**IN THE MATTER OF** Proposed Plan Change E: Roxburgh Residential  
Area to the Palmerston North City Council  
District Plan

**SUPPLEMENTARY STATEMENT OF EVIDENCE OF EAMON MICHAEL GUTHRIE AND ANDREA  
MICHELLE HARRIS ON BEHALF OF PALMERSTON NORTH CITY COUNCIL**

**Dated: 25 JUNE 2025**

**Map 7.10 B(1) Roading Cross Sections for area marked 'D' (centre of site) on the Structure Plan in Map 7.10 to show Southern Open Space Area Option.**

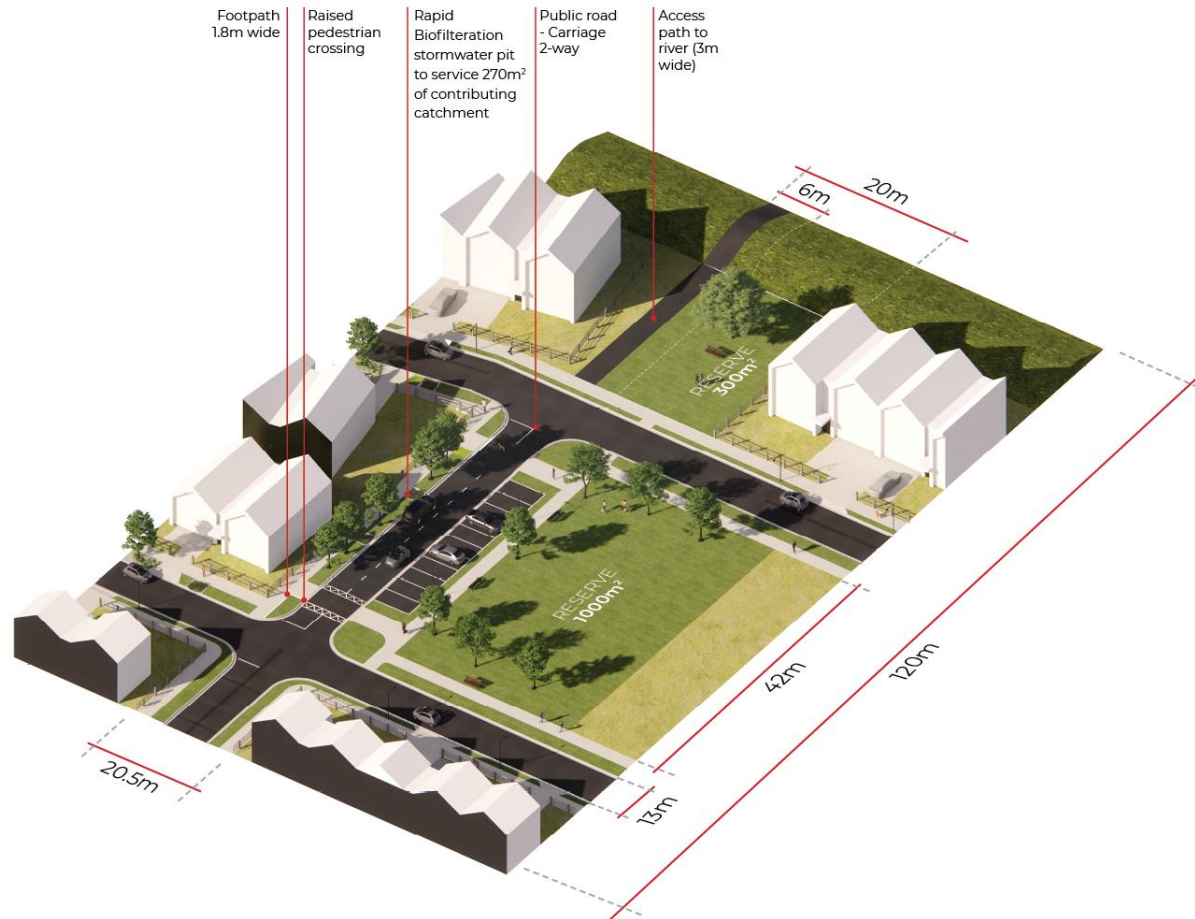
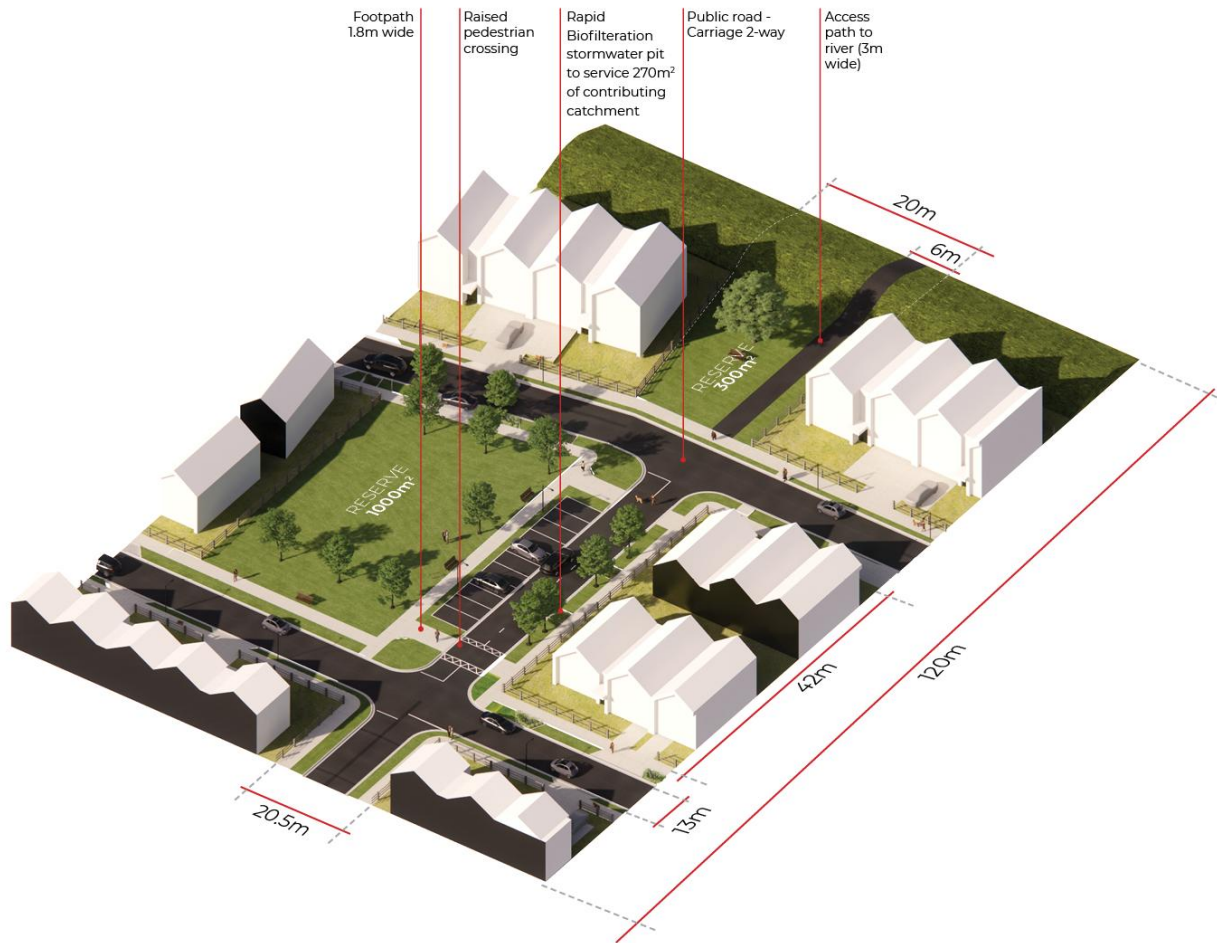
- [73] Following planning conferencing, amendments to Map 7.10 B for the Roding Cross Section adjacent to Road 'D' have been made to show where the Open Space Areas could be located in the Roxburgh Residential Area. These changes show the minimum open space areas and dimensions, and acceptable locations within the Roxburgh Residential Area. We refer the Hearing Panel to **Attachment A** for the changes.

**Map 7.10 C** Roading Cross Section Road E Laneway

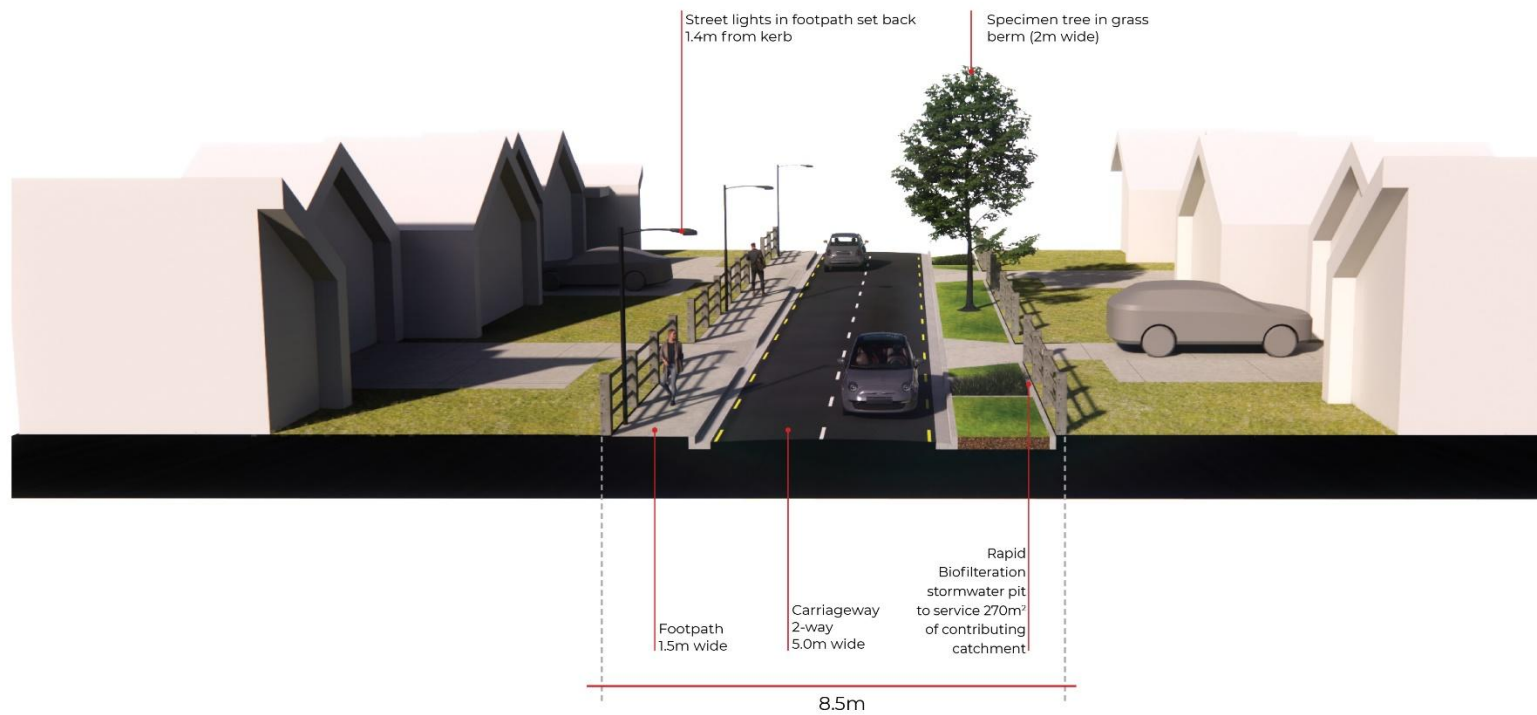
[14] In addition, we have recommended changes to provisions and the associated plans and cross-sections, arising from consideration of the above matters, with a set of marked up provisions attached as **Attachment A**, along with an updated Structure Plan (Map 7.10), updated road cross sections for Road D (Map 7.10 B) and a new Laneway cross section for Road E<sup>1</sup> (Map 7.10 C).
